ADDENDUM NO. 6 TO PROJECT NO. 44014

CONSTRUCTION WORK, HVAC WORK, PLUMBING WORK, AND ELECTRICAL WORK
PROVIDE CITYSCAPE COMPLEX
STATE PREPAREDNESS TRAINING CENTER
5900 AIRPORT ROAD
ORISKANY, NY

September 10, 2012

3 MUA-1
M-700 NO SCALE

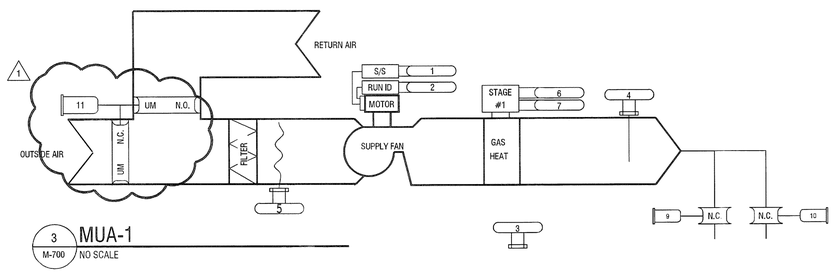
33. Drawing No. FA-601, FIRE ALARM ONE LINE DIAGRAM:
    a. DETAIL 1: Change "RTU-1" mechanical equipment designation to read "MAU-1" for the control unit Outside Motel Room 120 providing the control.
    b. DETAIL 3:
        1) Add "75" candela rating for 'MALL CORRIDOR 202' training horn strobe.
    c. DETAIL 4:
        1) Change "0" total for 15 candella ASB-24MCC to read "11".
        2) Change "0" total for 75 candella ASB-24MCC to read "3".
